To: T10 Technical Committee
 From: Rob Elliott, HP (elliott@hp.com)
 Date: 4 March 2006
 Subject: 05-381r2 SAS-2 Multiplexing

Overview

Figure 3 — Phy class diagram

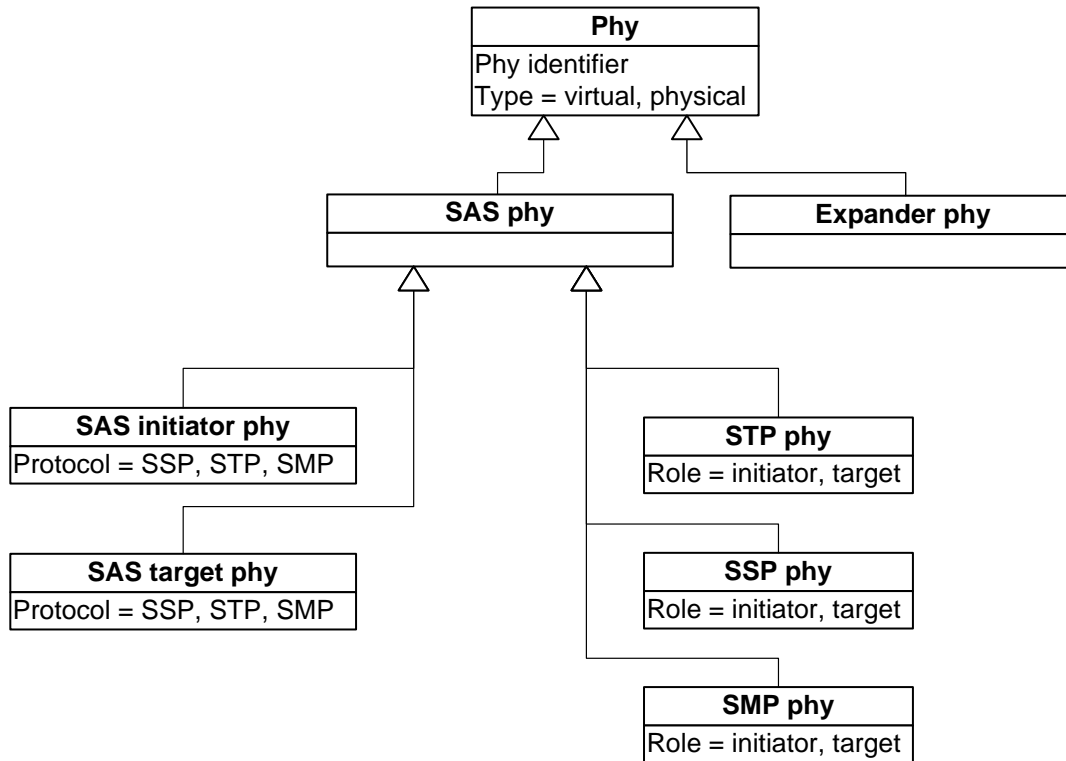
Editor's Note 1: Logical phys probably need to be included in the UML model, perhaps just as another attribute or a new value in the Type attribute.

Figure 21 — Multiplexing

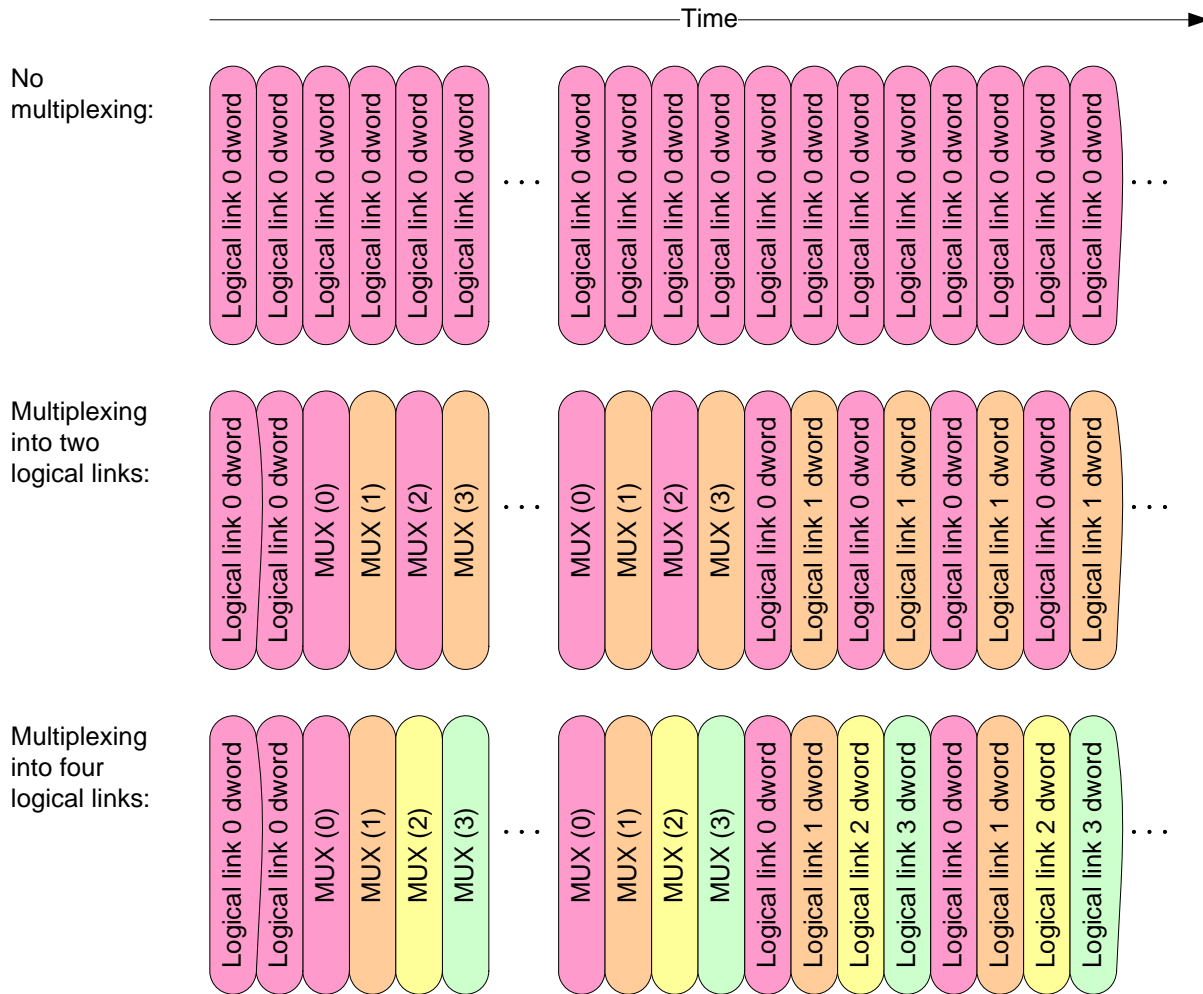
[The phy shall ignore all incoming dwords except MUX primitives. Incoming MUXes during the multiplexing sequence are not accompanied by ALIGNs and/or NOTIFYs, so the phy shall process them in logic running off the received clock, without using an elasticity buffer.](#)

After the phy receives at least 3 MUX primitives confirming the position of dwords in each logical link, it shall continue transmitting at least 24 MUX primitives. The phy shall then stop transmitting MUX and the logical phys shall start transmitting dwords for the logical links in the corresponding positions as shown in figure 21.

Figure 22 — SL_IRM (link layer identification, and hard reset, and multiplexing) state machines

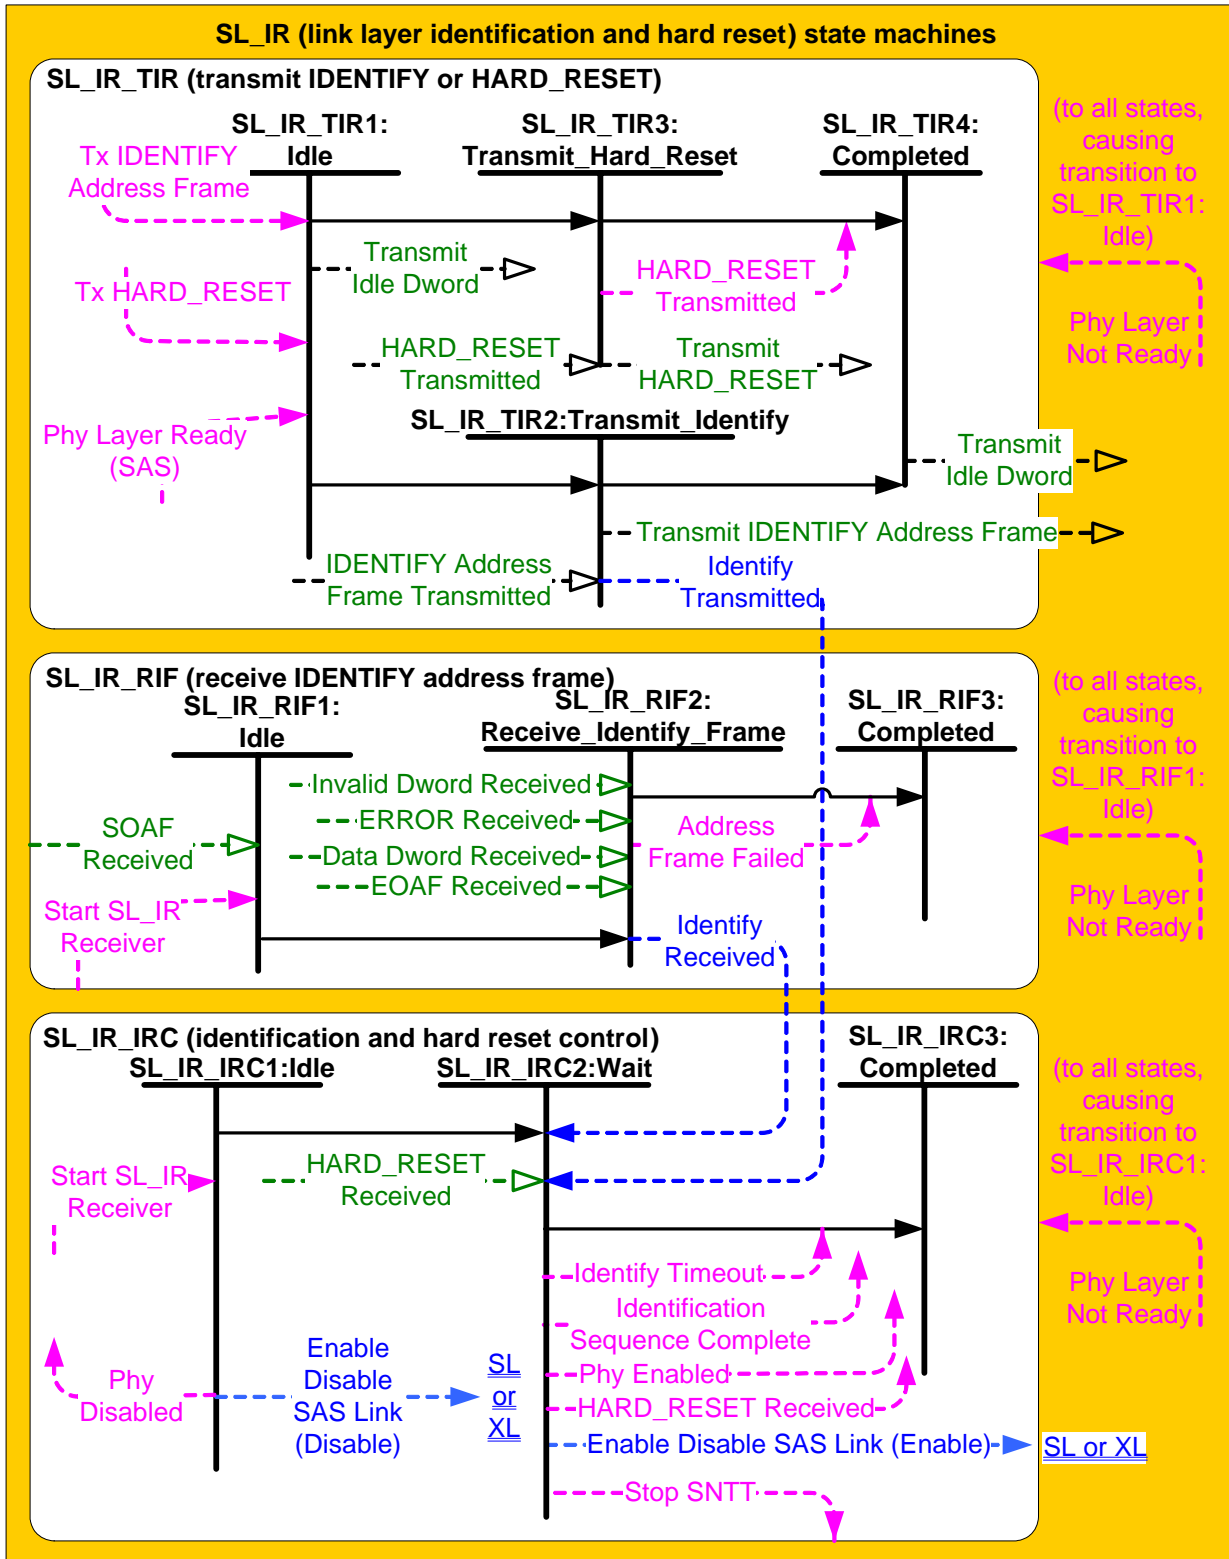
[Editor's Note 7: Add state\(s\) to handle the multiplexing sequence.](#)

[Editor's Note 8: Add state\(s\) to handle the multiplexing sequence.](#)

[Editor's Note 9: Add state\(s\) to handle the multiplexing sequence.](#)
